Groundwater Application Review Summary Form

Application # G- 18805

SUBJECT: Application G- 18805 Supersedes review of na
Date of Review(s)

A1. Applicant(s) seek(s) 0.009 cfs from 1 well(s) in the Willamette Basin,
Tualatin subbasin

Hydrograph of Nearby Wells

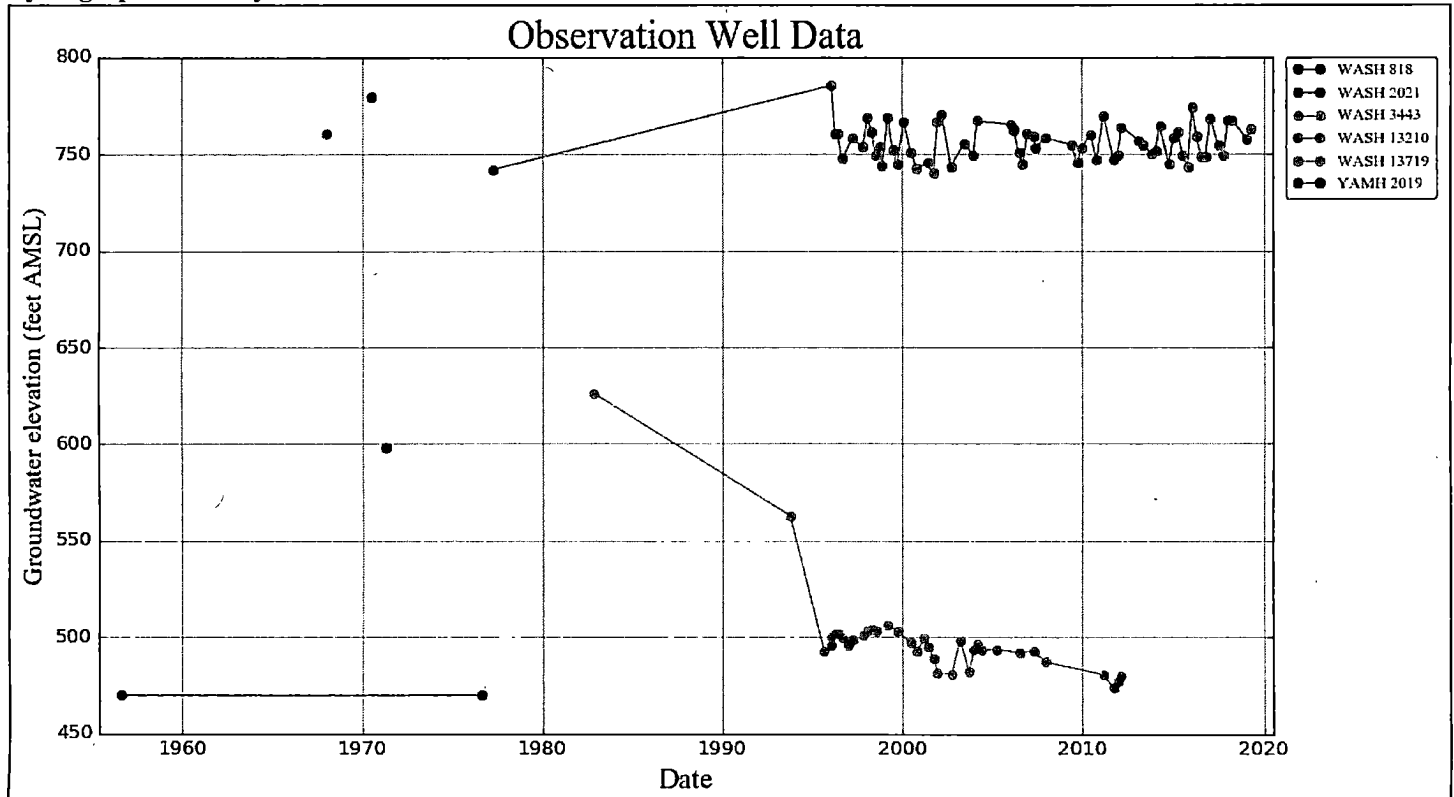
Based on nearby well logs there appear to be at least two distinct basalt aquifers in this vicinity (see hydrograph below). Shallower wells (completed to elevations of approximately 600 feet or higher above sea level (asl)) have water elevations around approximately 760 feet asl (see WASH 13210, WASH 13719 and YAMH 2019 in the hydrograph and comparative lithology below). It appears that the local streams intersect this aquifer. Deeper wells have water elevations around approximately 500 feet asl (see WASH 3443, WASH 808 and WASH 2010 in the hydrograph and comparative lithology below). The applicant's well needs to be constructed so that it is only completed in the lower basalt aquifer to avoid hydraulic connection with the nearby streams.

1. Groundwater production in each well shall be limited to a single aquifer in the Columbia River Basalt Group.
 - a. Each well shall be continuously cased and continuously sealed into hard dense basalt at a depth of 75-100 feet below the local level if stream incision, which in this case is Chicken Creek at an elevation of 245 feet above sea level. For the proposed well location this means the well must be continuously cased and continuously sealed into hard dense basalt at a depth of at least 470 feet below land surface.
